Twickenham Riverside

DATE:	17 December 2021	CONFIDENTIALITY:	Confidential
SUBJECT:	LBRUT Transport Comments Review - WSP Response		
PROJECT:	Twickenham Riverside	AUTHOR:	Tim Gabbitas / Tom Edwards
CHECKED:	Tim Gabbitas	APPROVED:	DRAFT

[1] OVERVIEW

This document has been produced by WSP in response to the London Borough of Richmond upon Thames (LBRUT) document “*Twickenham Riverside – highways comments feedback to applicants (November 2021)*”.

DRAWING No: 70059704-TP-SK-68 REV: P01

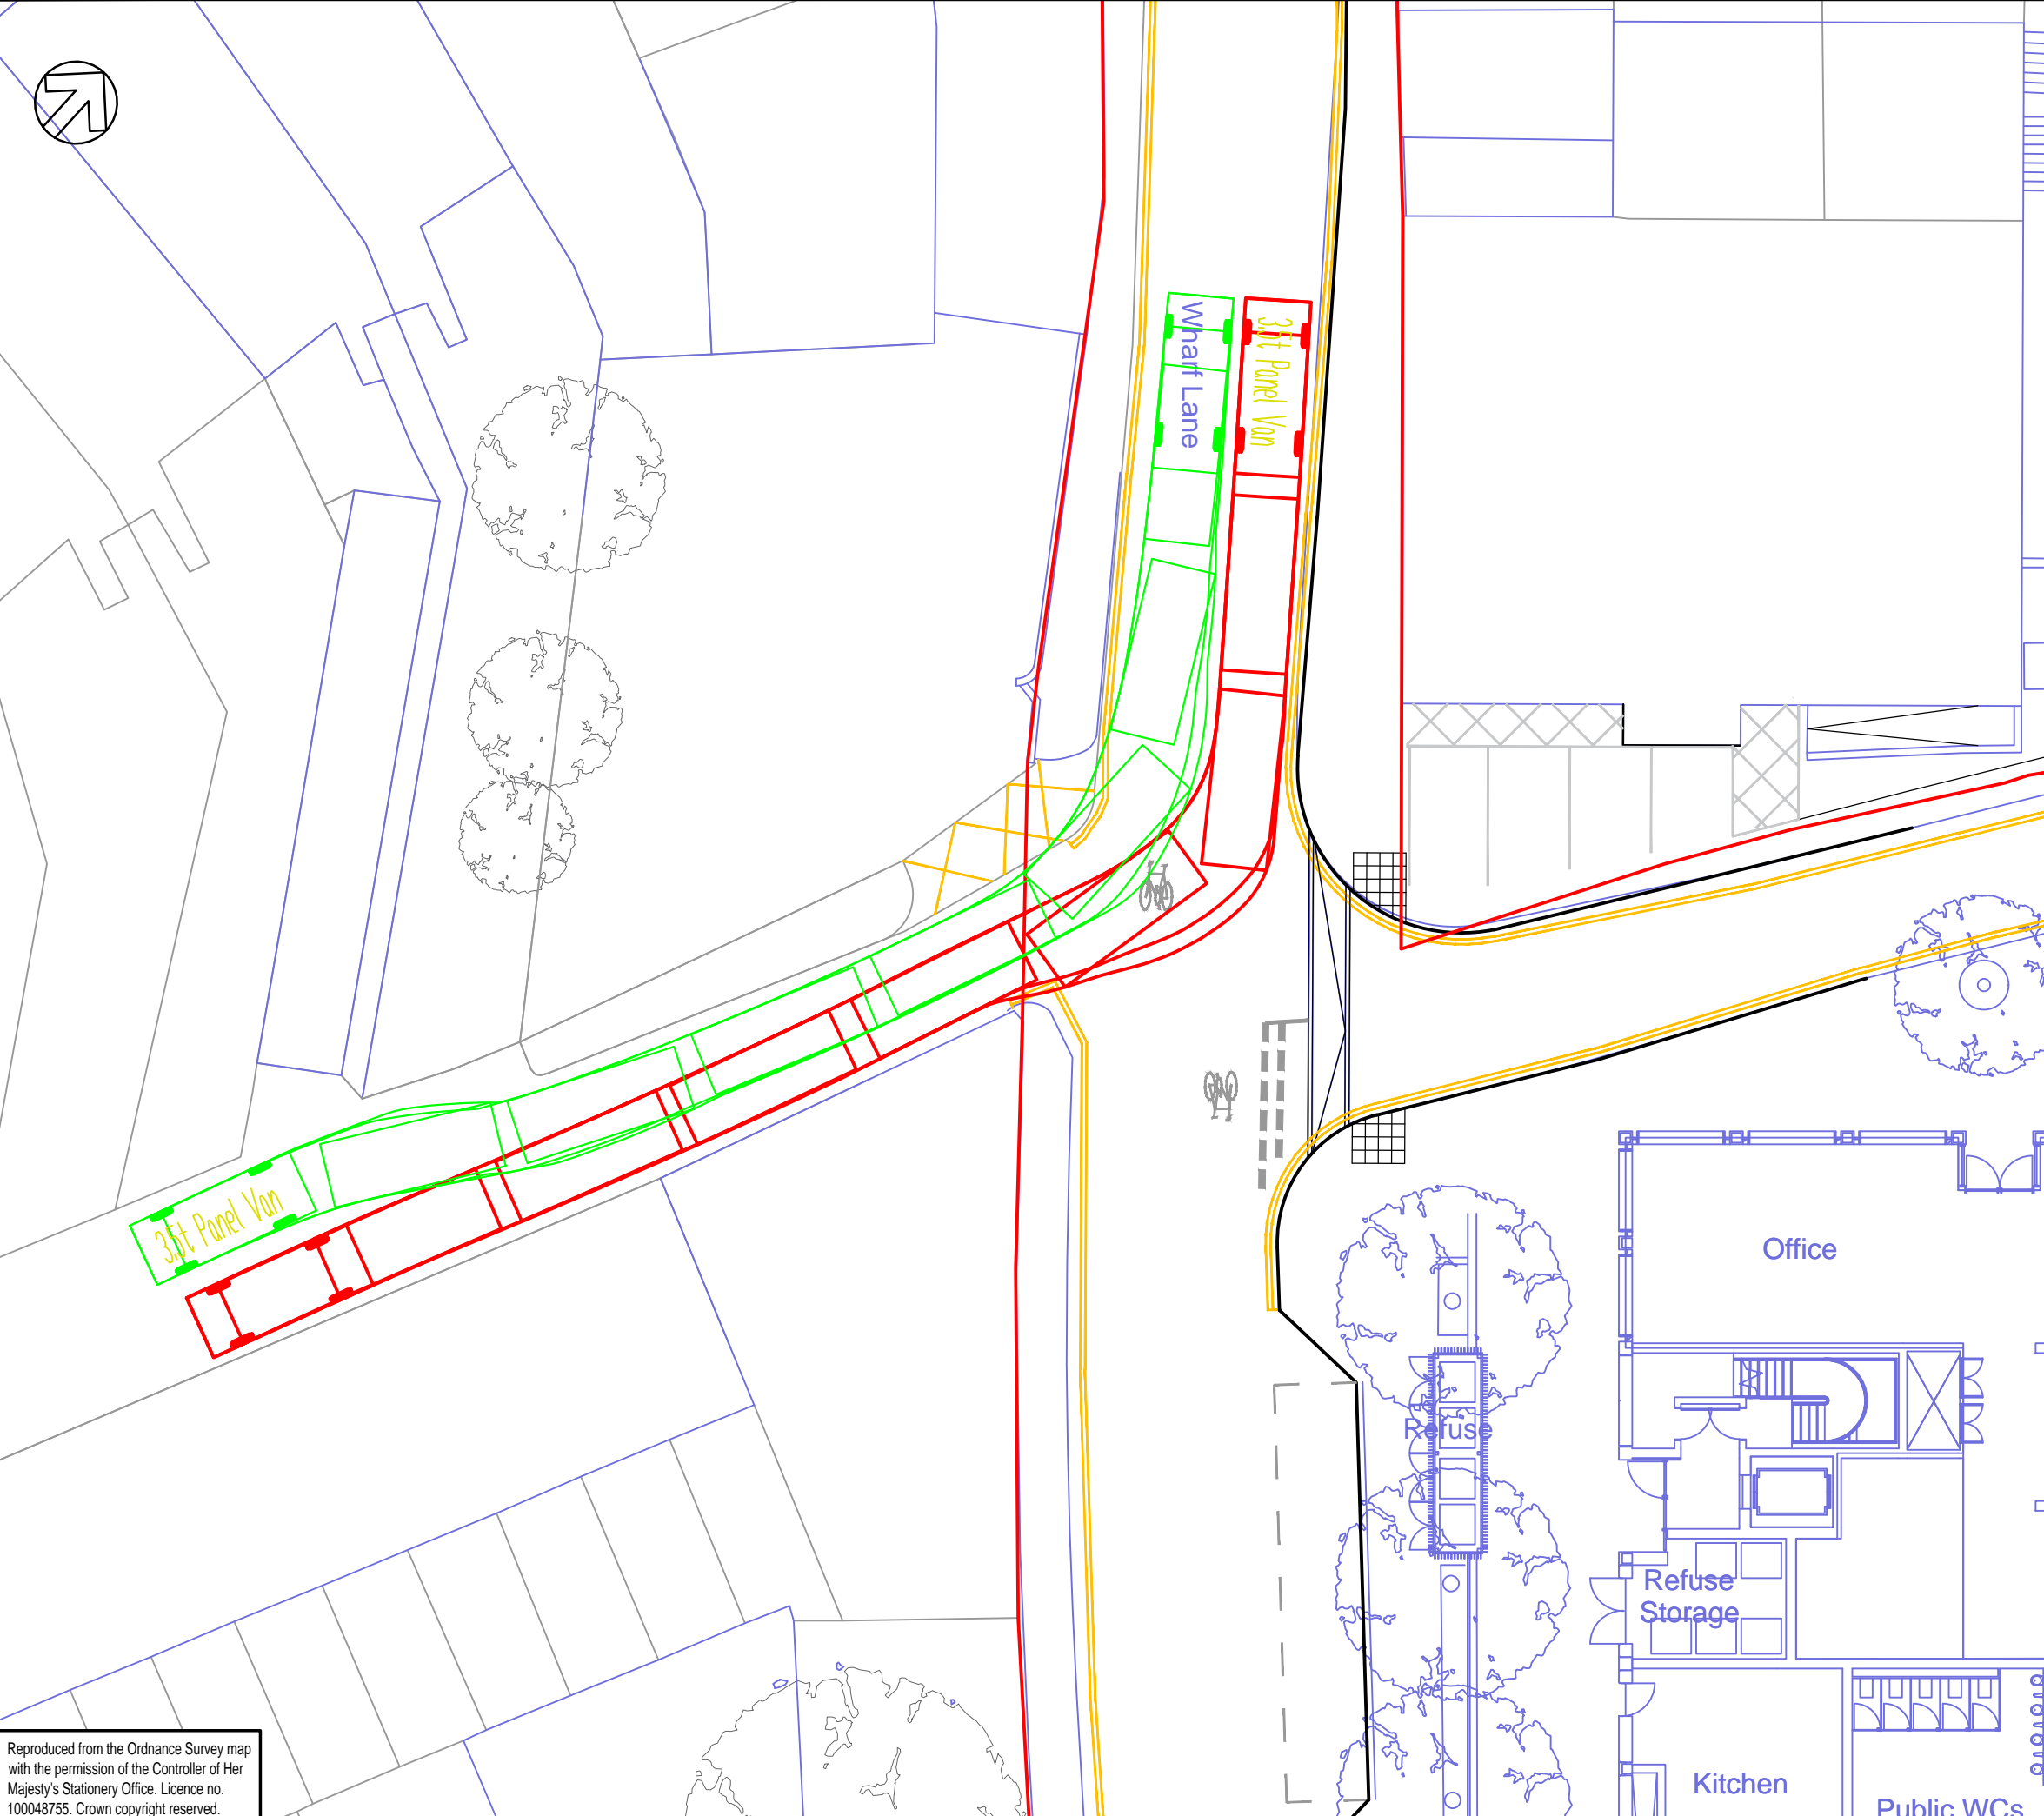
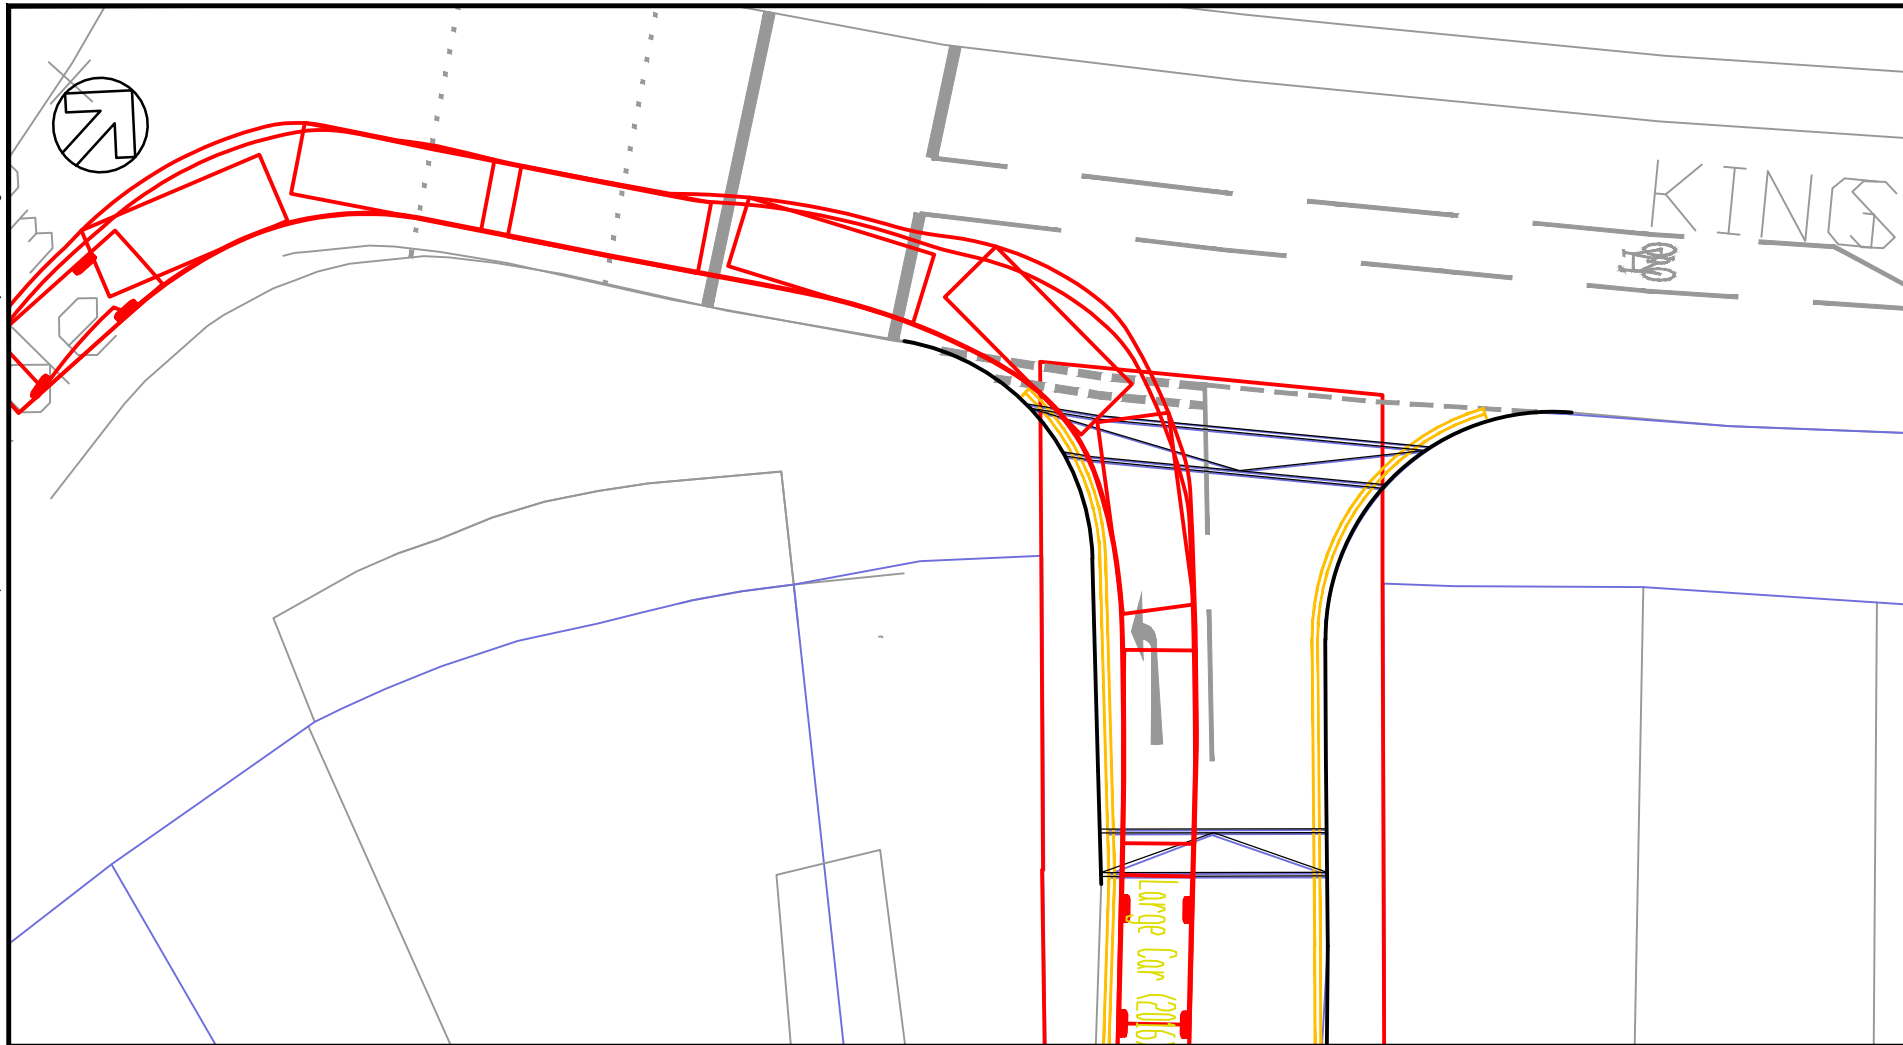
i) Can service (and service vehicles) manoeuvre into and out of the private access road to the west of Wharf Lane – this is not shown on the Swept Plans.

- Vehicle tracking showing the left-turn from Wharf Lane onto King Street demonstrates that the majority of vehicles making this movement (cars, vans and small 7.5t trucks) can do so without encroaching into the offside (ahead) lane on King Street. Tracking drawing [SK-69_P01](#) illustrates this movement for a large car and a 7.5t box van.

TITLE:
 HOPKINS MASTERPLAN
 PROPOSED HIGHWAY ARRANGEMENT
 PROP SERVICE RD BAY & FIRE PASSING

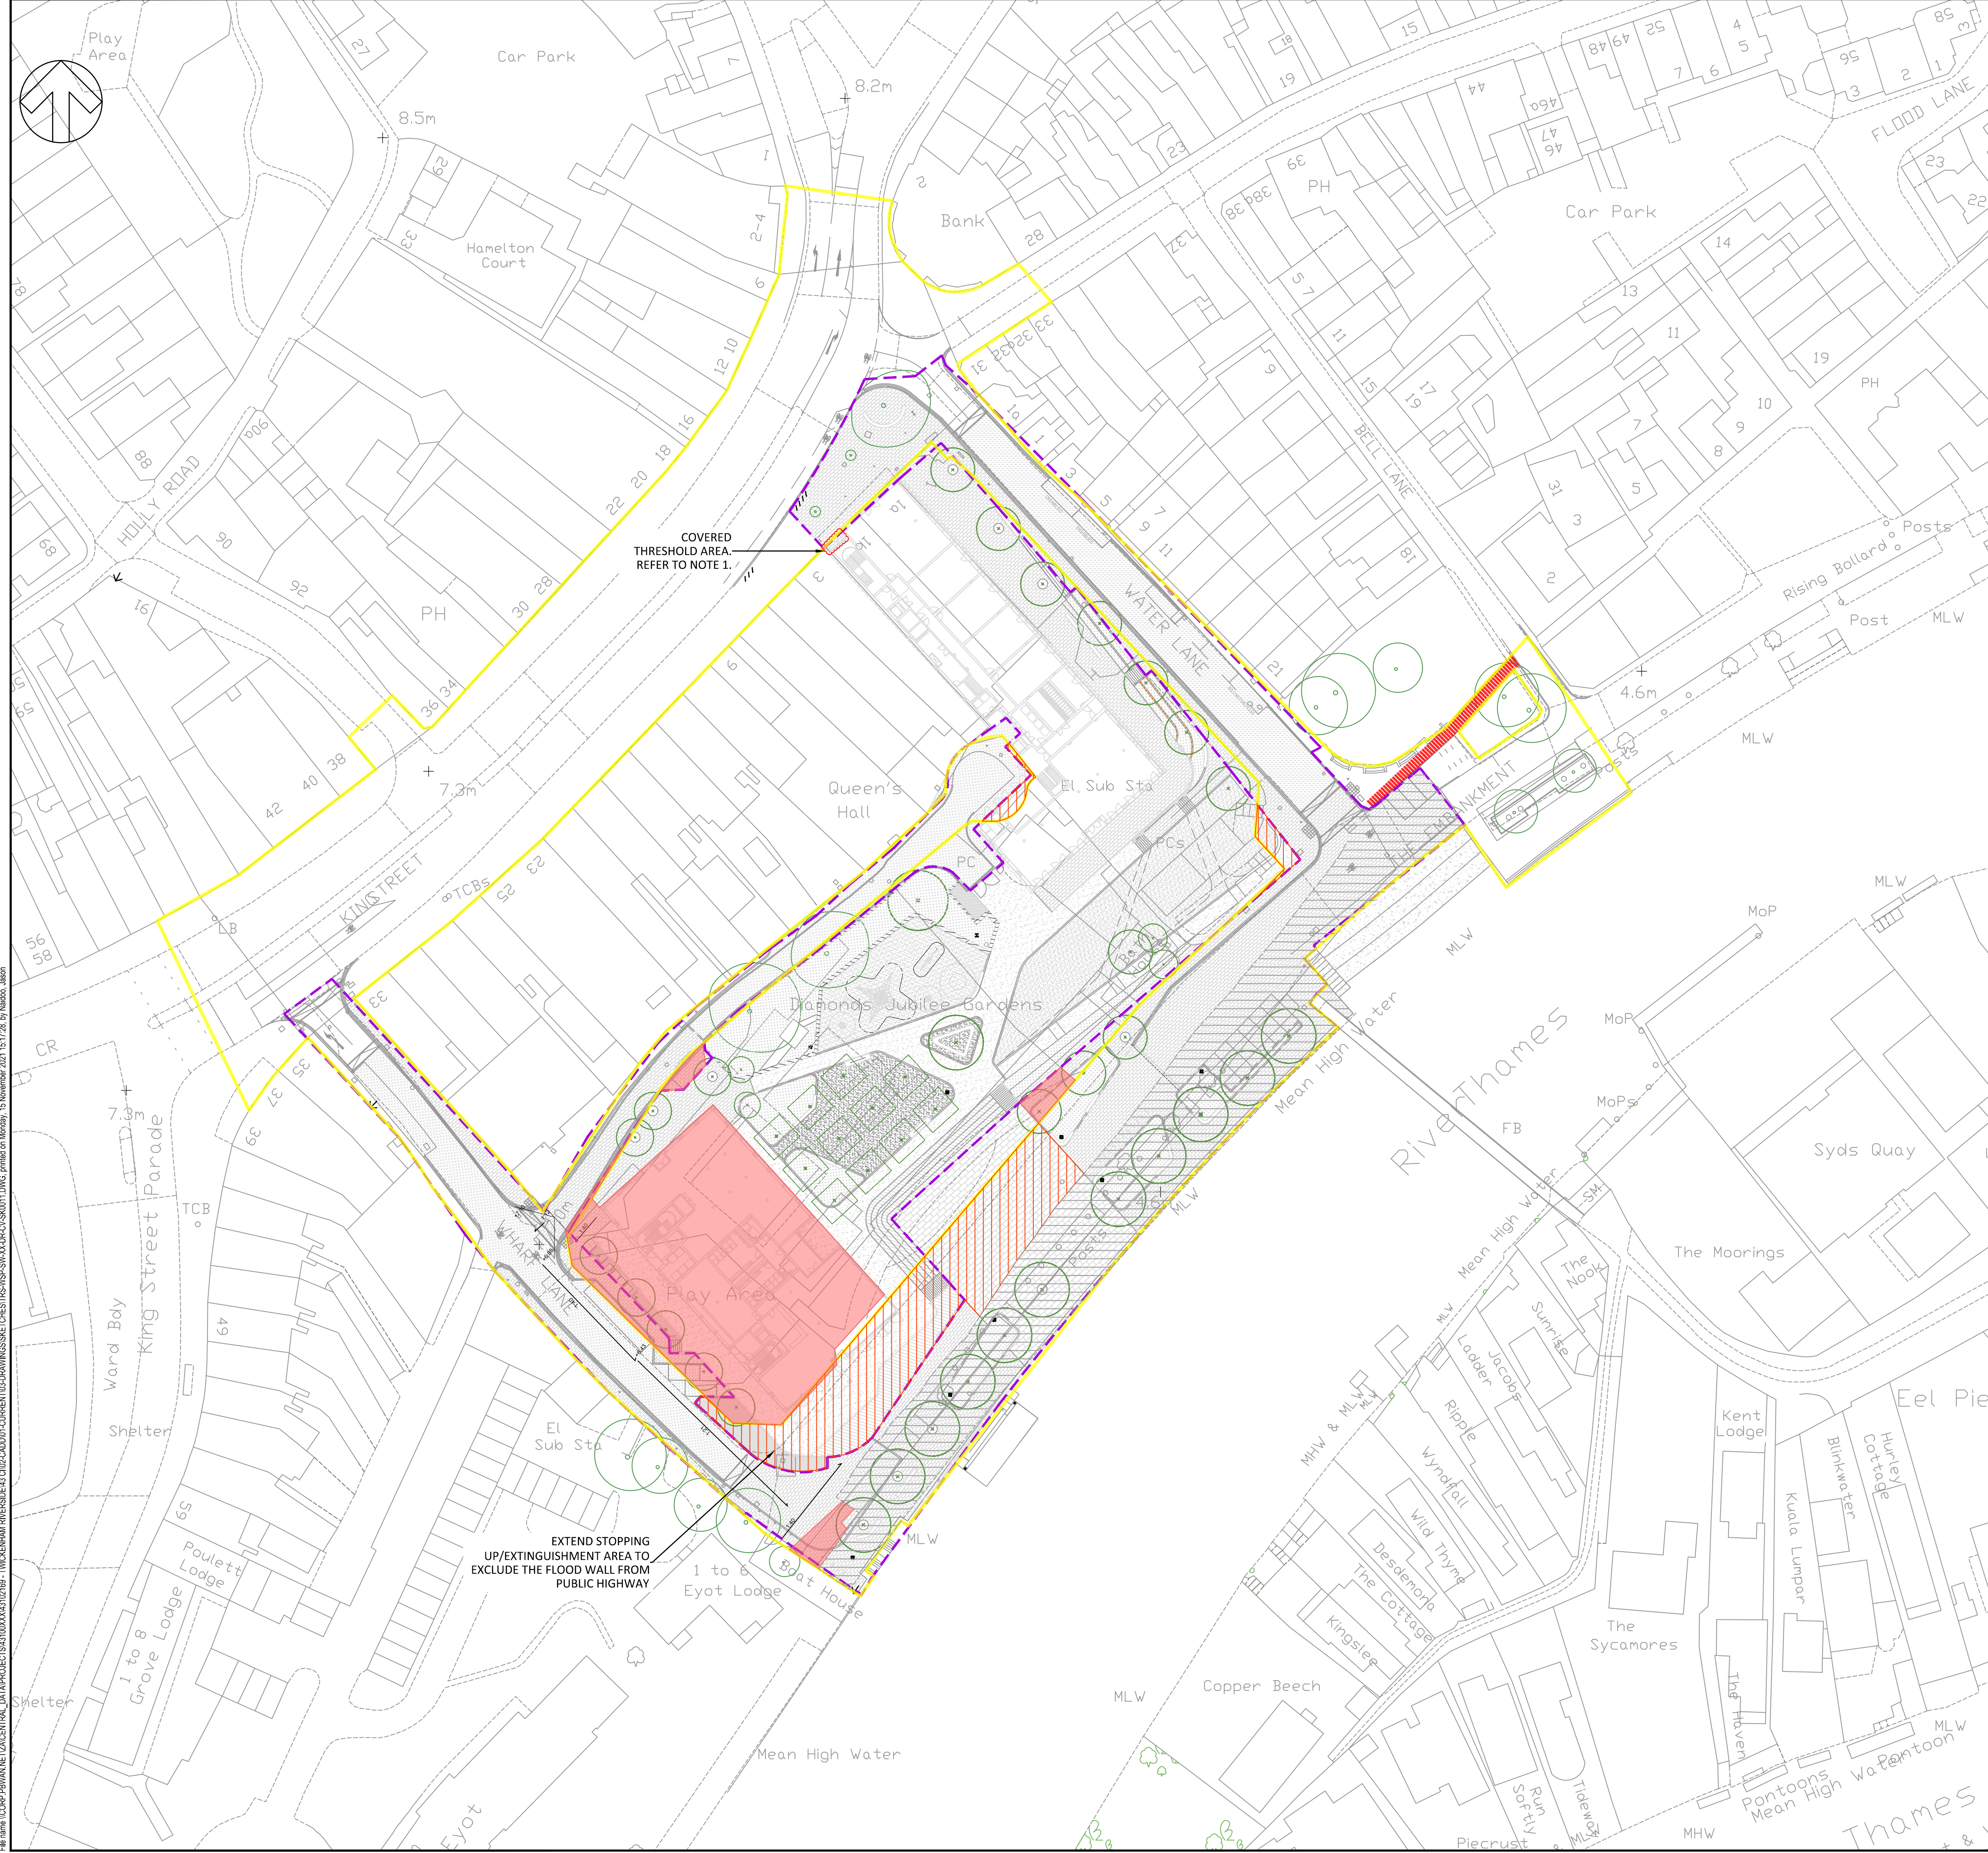
- a) The swept paths show service vehicles cannot make manoeuvre without overhanging the narrow footway on the northern side of the service road and at the back edge of the existing turning circle. This needs to be addressed given that a lot of residents living in flats above 1-33 King Street have rear pedestrian accesses and rely in this footway. The refuse truck manoeuvre is reliant on the gates being opened. It is suggested the gates are removed, and bollards are installed further south.
